KMLNRC 84-099
Re: Docket No. STN 50-482
Subj: Quality Assurance Program Changes

Transmitted herewith are changed pages to the Wolf Creek Operating Quality Program described in the Wolf Creek Final Safety Analysis Report. The attached material also describes the reason for the change and the basis for concluding that the change does not reduce the KG&E commitments in the Operating Quality Program previously accepted by the NRC.

SNUPPS-WC

17.2 QUALITY ASSURANCE DURING THE OPERATION PHASE

FIGURE 17.2-3

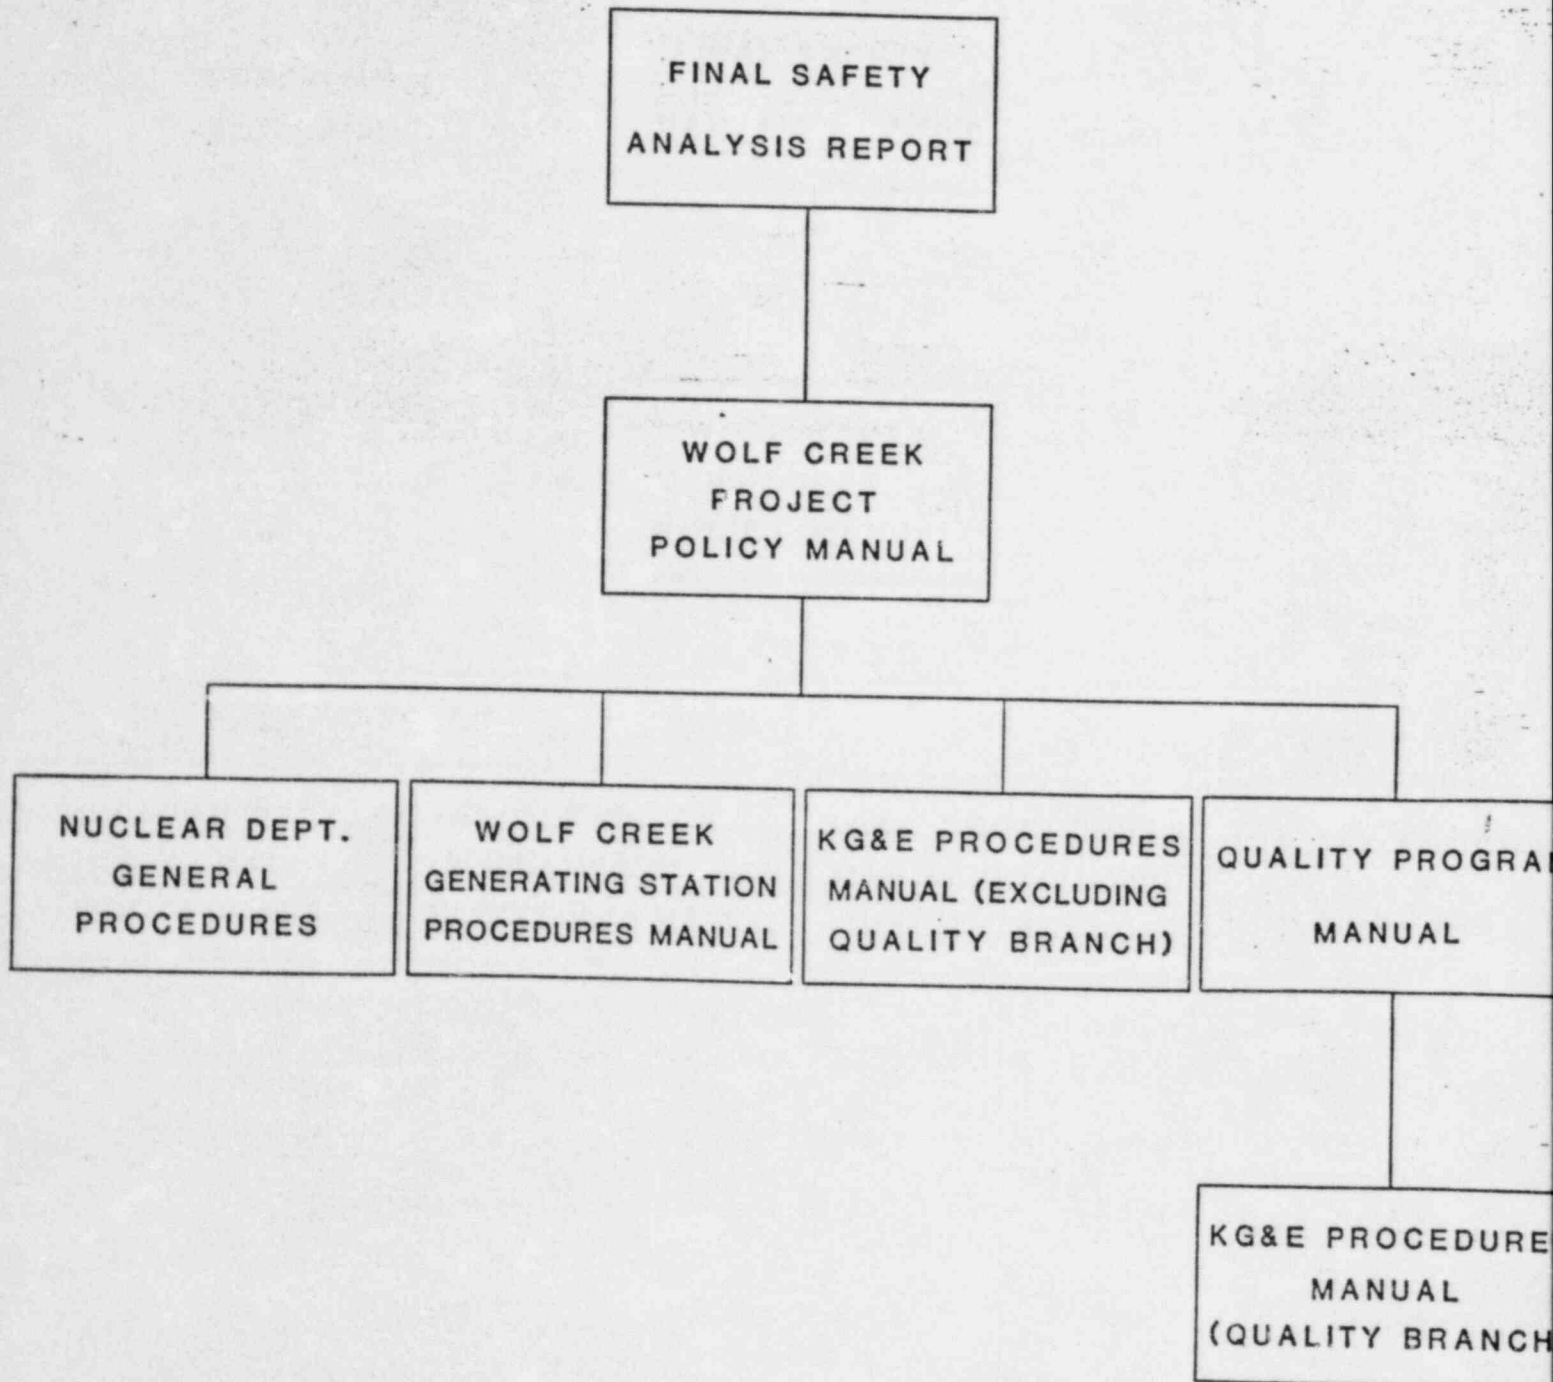
This change expands the description of the manuals and/or clarifies their function and interrelation.

No program change has been made with regard to this text change. The manual descriptions have been changed per a request from the NRC.
